LETTER REGARDING JP 4 PIPELINE IN FLIGHT LINE DITCH AND RECOMMENDATIONS
THAT THE PIPELINE BE TAKEN OUT OF SERVICE NAS FORT WORTH TX
1/10/1991
RADIAN CORPORATION

**NAVAL AIR STATION
FORT WORTH JRB
CARSWELL FIELD
TEXAS**

Re: JP4 Pipeline in Flightline Ditch at Carswell AFB

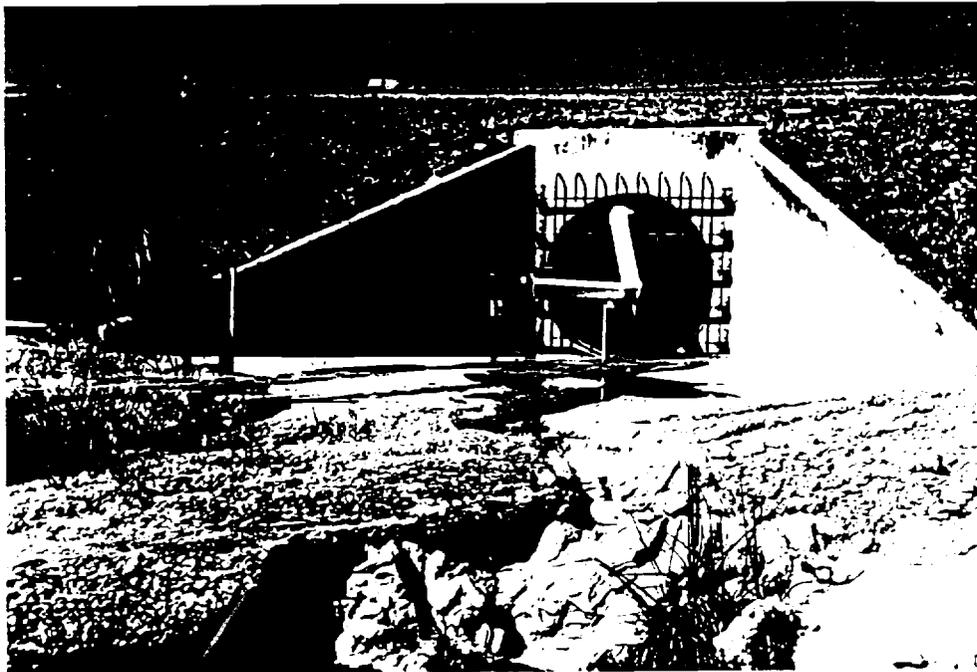
During a phone conversation with Frank Grey on 9 January 1991, Frank informed me that there is a pipe in the Flightline Drainage Ditch which carries JP4 fuel to the flightline. This pipe is exposed in the bottom of the ditch and runs along the inside (concentric) of the culvert to the flightline. I have attached a photograph of this pipe at it enters the culvert.

Radian is recommending that this pipe be taken out of service and rerouted along a different path. The reason for this recommendation is because the present location in the ditch exposes the pipe to excessive loads and stresses during periods of flow, increasing the risks of a rupture as compared to most above ground installations.

Radian also recommends relocation because the ditch is a direct connection to surface water sources which would increase the severity of any release. Please realize that during periods of high flow the concentrations would be reduced by the volume of water present, but the release would be more wide spread. In addition, it would be difficult to detect leaks or ruptures during high flow periods because the pipe would not be visible when submerged. During periods of low flow the release would be more concentrated and limited to a smaller surface area. In either case, the consequences would be detrimental to the environment.

In summary, Radian recommends that this pipeline be rerouted as soon as possible. The present location is not a suitable route for a hydrocarbon pipe line because the ditch serves as a direct hydraulic connection to the environment and because the storm water flows in the ditch add unnecessary loads to the pipe.
